MIL-C-172C  
AMENDMENT 6  
15 February 2001  
SUPERSEDING  
AMENDMENT 2  
20 October 1966

MILITARY SPECIFICATION

CASES; BASES, MOUNTING; AND MOUNTS VIBRATION (FOR  
USE WITH ELECTRONIC EQUIPMENT IN AIRCRAFT)

FIGURE 6. Automatic locking device.

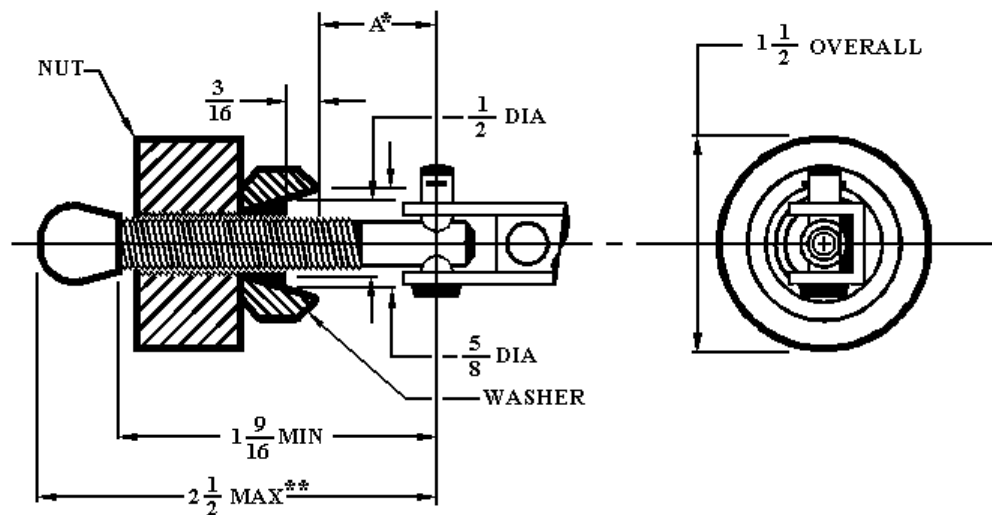
3.5.2.1: Delete and substitute:

“3.5.2.1.2 Automatic locking devices. For all Air Force procurement only automatic locking devices shall be use in all cases, bases, and mounts to prevent loosening thereof under vibration. Dimensions shall be within the envelope shown in figure 6. For Army and Navy procurement automatic looking may be used provided they are specified by the procuring activity.”

Insert figure 6:

\* CLEARANCE ON OPEN OR EXTENDED POSITION 1-3/8 MINIMUM FOR DIMENSION A

\*\* THIS DIMENSION SHALL BE NO GREATER THAN NECESSARY TO MEET THE MINIMUM CLEARANCE OF DIMENSION A

MATERIAL: CORROSION-RESISTANT STEEL
